SUBJECT: Calvert Cliffs Nuclear Power Plant
Unit No. 1; Docket No. 50-317
Response to Request for Additional Information Regarding Interim Inspection
Requirements for Reactor Pressure Vessel Head (TAC No. MC1921)

RESPONSE TO NRC REQUEST FOR ADDITIONAL INFORMATION

RELAXATION REQUEST 1

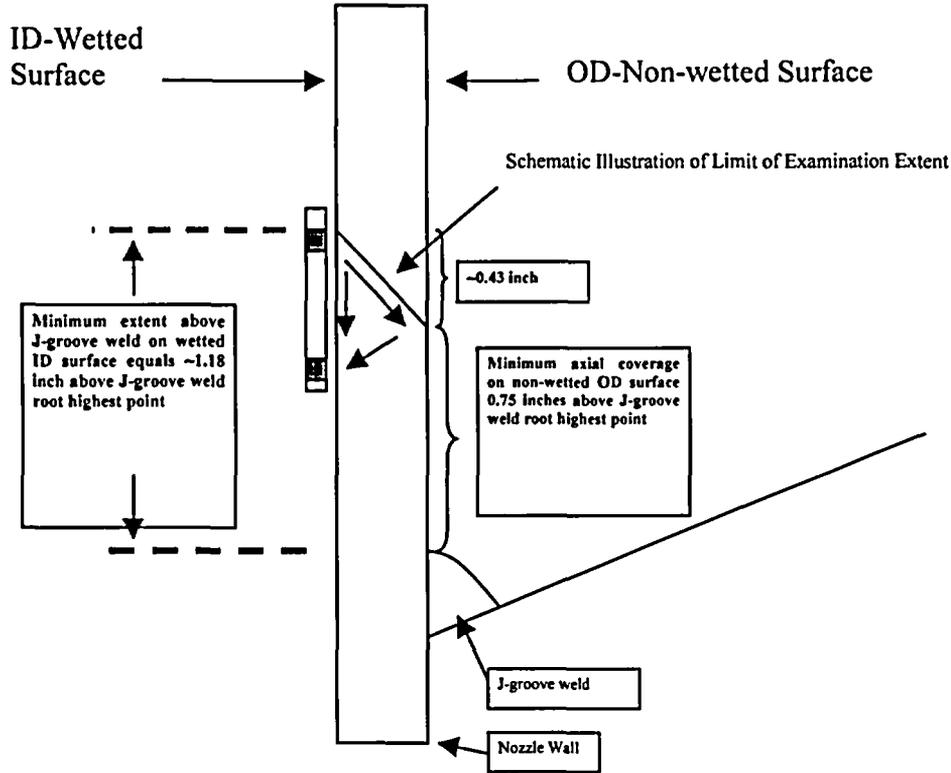
Please provide justification that coverage up to 0.75 inches above the weld will provide an adequate level of quality and safety. Are there residual stress data for Unit 1 that indicates that 0.75 inches is a sufficient level above the weld, or is there any other basis that demonstrates an acceptable level of quality and safety for the restricted inspections?

Calvert Cliffs Nuclear Power Plant (CCNPP) has had several plant specific stress analyses, fracture mechanics analyses, and operational experience analyses performed. All of these analyses support the conclusion that examination of an inspection volume encompassing the CEDM nozzle material up to 0.75 inches (on the OD) above the highest point of the root of the J-groove weld is sufficient to ensure safety and quality. However, additional inspection of the region between 0.75 inches and 2 inches above the highest point of the root of the J-groove weld will be accomplished wherever possible, and we expect we will be successful on most of the nozzle circumference on nearly every penetration.

We request relaxation of the Order requirements so that we may inspect a minimum of 0.75 inches above the highest part of the root of the J-groove weld for the nozzle OD. On the nozzle ID, we request

relaxation so we may inspect a minimum of 1.18 inches above the highest part of the root of the J-groove weld, as shown below.

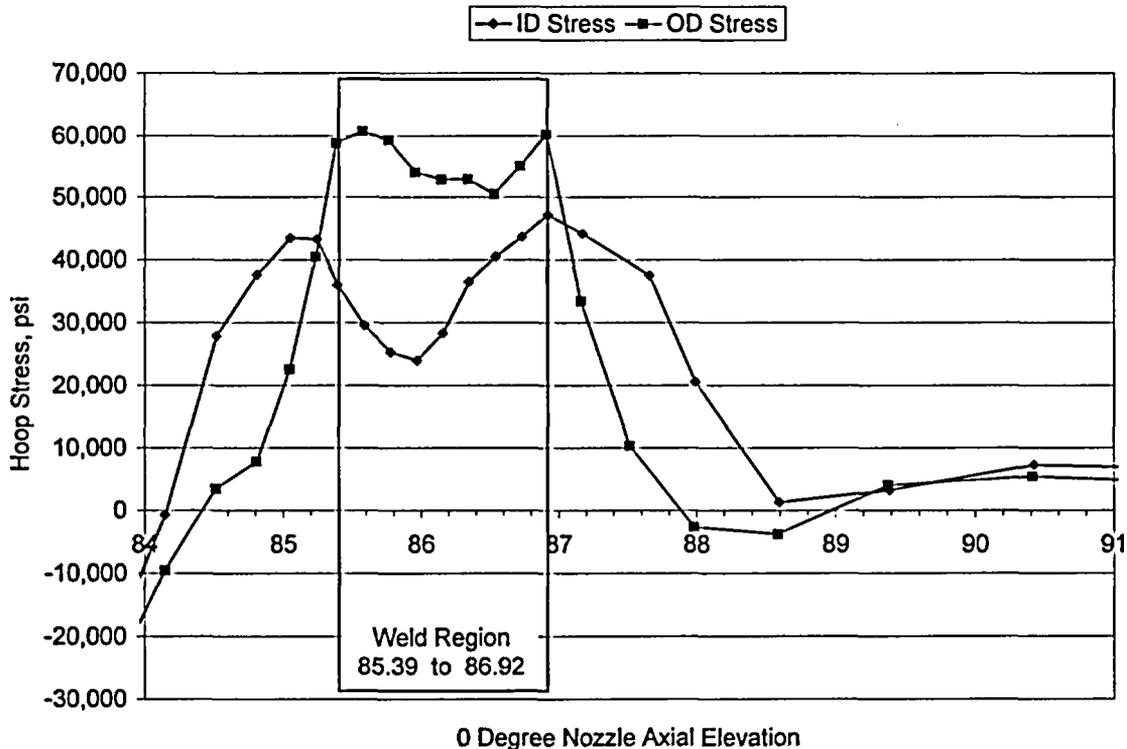
What is the maximum hoop stress in the bottom portion of the nozzle? Please provide crack growth predictions for through-wall axial flaws located at various angles in the CEDM's.

The following table provides a summary of the results for the 0 degree nozzle:

This table shows that the lowest elevation in the 0 degree nozzle that experiences a hoop stress of 20 ksi or above is 1.0 inch below the toe of the weld on the ID, uniformly around the circumference. The following plot shows the results graphically.
